Access Compliance Report

Public Rights-of-Way

(Pedestrian Signals)

Intersection ID: N/A	Main Street:	Cross Street: N/A	Location: N/A
ADA ID: 8755AEE1B032	Signal Type: One Push Button-Non APS	Overall Compliance: No	Severity Score: BTN 1: N/A BTN 2: N/A No BTN: N/A
Codes/Mitigation Info/Possible Solution		Field Measurements/Component Compliance

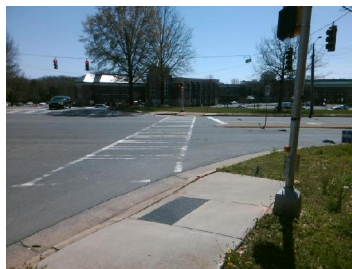
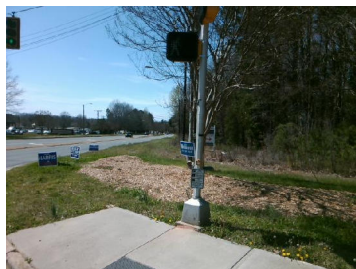
N/A	B 1 FWD Approach Width (in)	N/A	N/A	B 2 FWD Approach Width (in)	N/A
N/A	B 1 FWD Approach Obstruction?	Yes	N/A	B 2 FWD Approach Obstruction?	N/A
N/A	B 1 FWD Approach Obstruction Dist (in)	2.0	N/A	B 2 FWD Approach ObstructionDist (in)	N/A
N/A	B 1 PARA Approach?	Yes	N/A	B 2 PARA Approach?	N/A
N/A	B 1 PARA Approach Constrained?	Yes	N/A	B 2 PARA Approach Constrained?	N/A
Yes	B 1 PARA Approach Reach (in)	6.0	N/A	B 2 PARA Approach Reach (in)	N/A
No	B 1 PARA Approach Width (in)	48.0	N/A	B 2 PARA Approach Width (in)	N/A
N/A	B 1 PARA Approach Obstruction?	No	N/A	B 2 PARA Approach Obstruction?	N/A
N/A	B 1 PARA Approach Obstruction Dist (in)	3.0	N/A	B 2 PARA Approach ObstructionDist (in)	N/A
No	B 1 Clear Floor Space Slope (%)	10.5	N/A	B 2 Clear Floor Space Slope (%)	N/A
No	B 1 Clear Floor Space XSlope (%)	5.8	N/A	B 2 Clear Floor Space XSlope (%)	N/A
N/A	B 1 PAR Slope (%)	N/A	N/A	B 2 PAR Slope (%)	N/A
Yes	B 1 Height (in)	38.0	N/A	B 2 Height (in)	N/A

N/A	B 1 Clear Xing Direction?	Yes	N/A	B 2 Clear Xing Direction?	N/A
	B 1 Crossing Direction	To SE		B 2 Crossing Direction	N/A
No	B 1 DistanceTo XWalk (in)	76.0	N/A	B 2 DistanceTo XWalk (in)	N/A
No	B 1 DistanceTo Curb (in)	76.0	N/A	B 2 DistanceTo Curb (in)	N/A
Yes	B 1 Diameter (in)	2.0	N/A	B 2 Diameter (in)	N/A

Possible Solutions: Replace Signal Push Button With APS Button on New Post. Remove & Relocate Sign.
